Product Change Notification

Change Notification #: 117440 - 00
Change Title: Intel® Server System Spare
AXXSATADVROM ,
PCN 117440-00, Product Design, Label,
Optical Pick Up, Cover Bottom, Frame,
Size of label
Date of Publication: February 21, 2020

2. Change of Cover Bottom

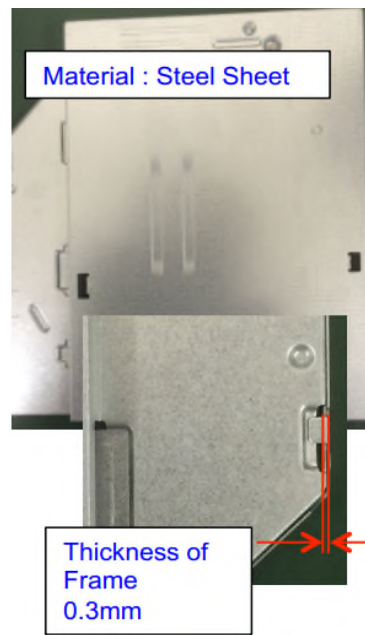
Pre change

Post change

3. Change of frame

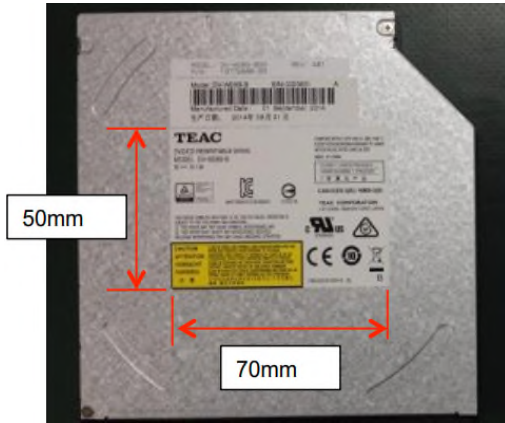
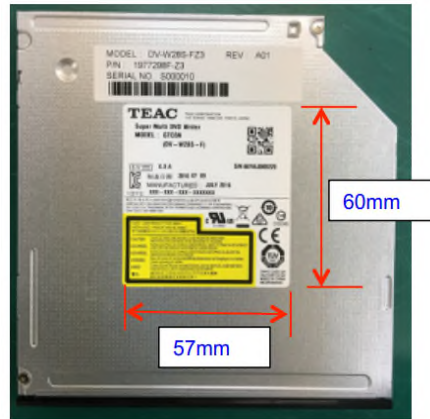
Pre change

Post change
